## 10219 Land at Valley Park, Didcot

### Technical Note 36: Design Rationale and further Amendments – Southern Roundabout Access

Dated 26<sup>th</sup> April 2021.

**Figure 2.1- Aerial View Existing 3 arm roundabout with constraints**

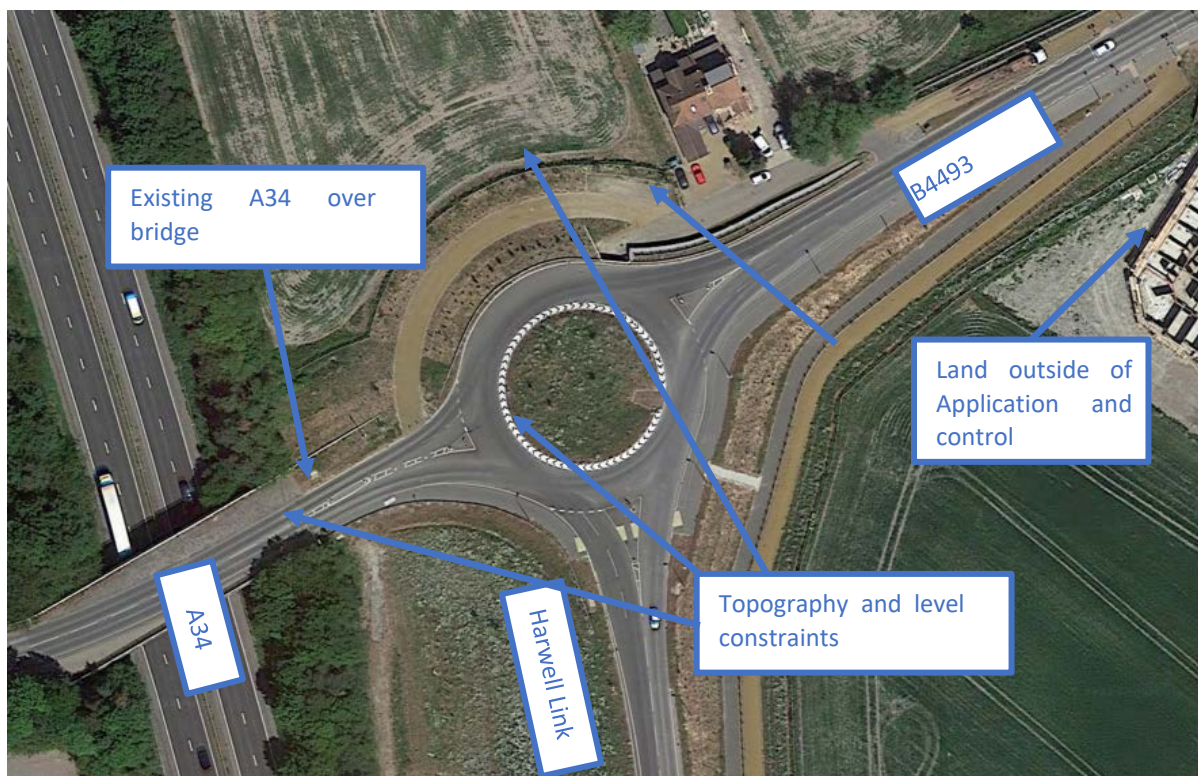
- 2.49** Assuming a large radial was pursued despite the issues as raised in terms of sizing and lane numbers in 2.27 of this document. There are physical constraints which would stop the implementation of such a large roundabout in this location, including topography, level differences, landowner ship, existing infrastructure such as the A34 and the over bridge. These are shown in figure 2.1 below.

Figure 3.1- New layout.

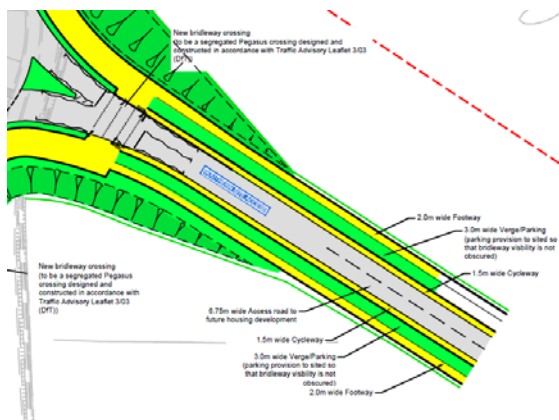
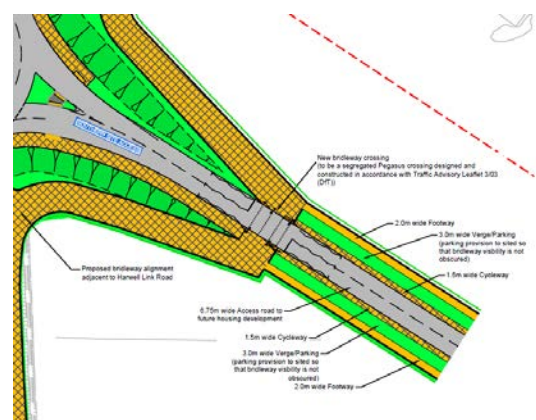
- 3.2 Proposed arm South East into proposed development.** Currently as shown below figure 3.2 is the original proposal with the Pegasus crossing set back from the roundabout in accordance with DMRB and to minimise gradients for DDA concerns. Following further analysis, it is believed that the crossing can be moved closer to the roundabout to reduce journey times and offer a more convenient facility for non motorised users. As discussed in section 2 of this document this should be around 20m away from the access and this is now shown in figure 3.1. This does introduce higher gradients to the footway/cycleway/bridleway than the current design, but these would remain within guidance for DDA concerns.

Figure 3.3- New layout.

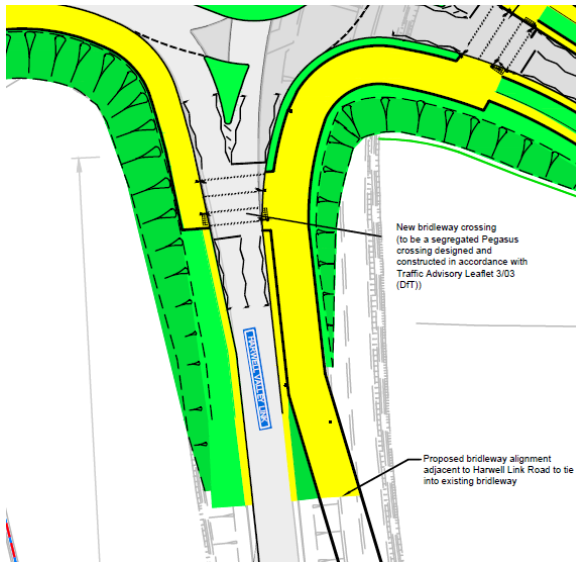
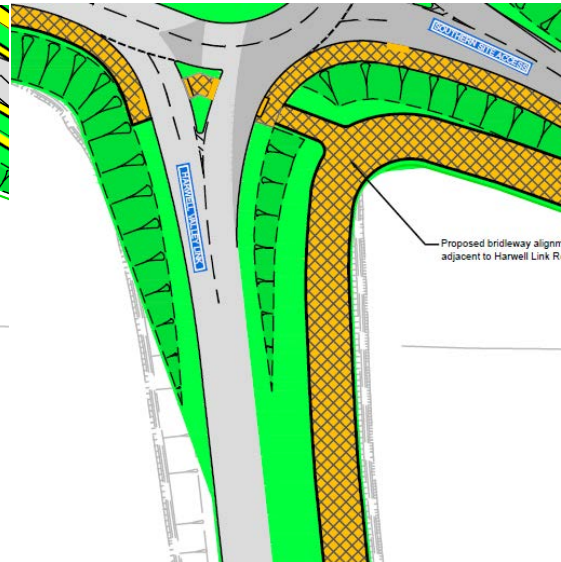
- 3.3 Existing Southern Arm to the Harwell Link.** Currently as shown below in figure 3.4 only provision for an uncontrolled crossing at the junction was shown. Given the changes to the new south east arm as described above, this now brings the footway/cycleway/bridleway up to the higher level and affords the opportunity to provide a new controlled Pegasus crossing on this arm, adding further facilities to east/west non motorised user traffic. This is shown in figure 3.3.

Figure 3.5- New layout.

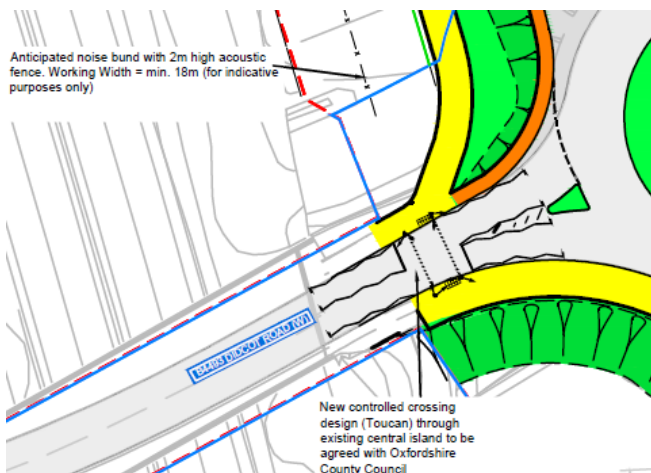
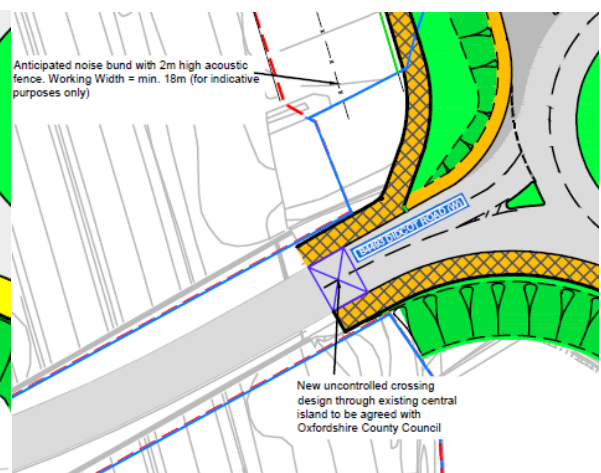
- 3.4 Existing Wester Arm bridge over the A34.** Currently as shown below in figure 3.6, only provision for an uncontrolled crossing at the junction was shown. Given the changes to the new south east arm and now the southern arm as described above, brings the footway/cycleway/bridleway up to the higher level and affords the opportunity to provide a new controlled crossing on this arm, adding further facilities to east/west non motorised user traffic, as well as north/south. Given the space constraints on the bridge it is believed that this is likely to be a Toucan or similar crossing and therefore in this area the extended facility is the Footway/Cycleway. This new arrangement is shown in figure 3.5.

**Figure 3.7- New layout.**

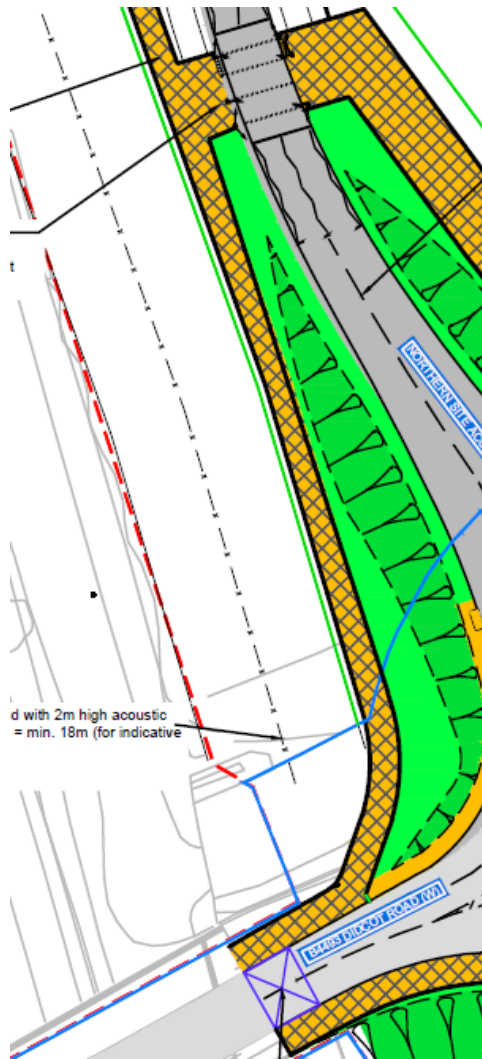
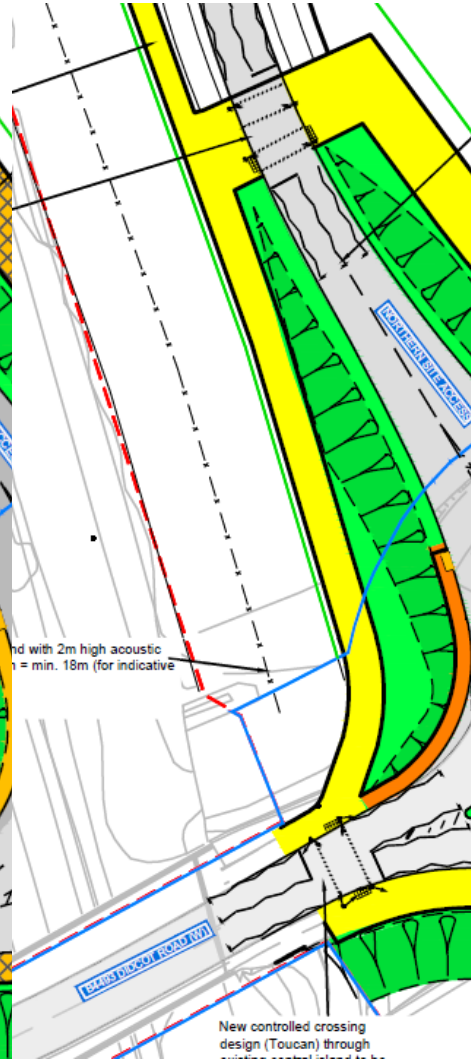
**3.5 Proposed arm North into development.** Level and restrictive constraints from the A34, proposed noise bunding and existing properties has limited further improvements here. However, the west side of the arm has a widened facility for pedestrians and cyclists from the proposed Toucan Crossing to the west and to this proposed Pegasus crossing on the northern arm. In addition, the Pegasus crossing has been moved as far south as possible given the constraints as detailed above. This is shown in the figures 3.7 and 3.8.
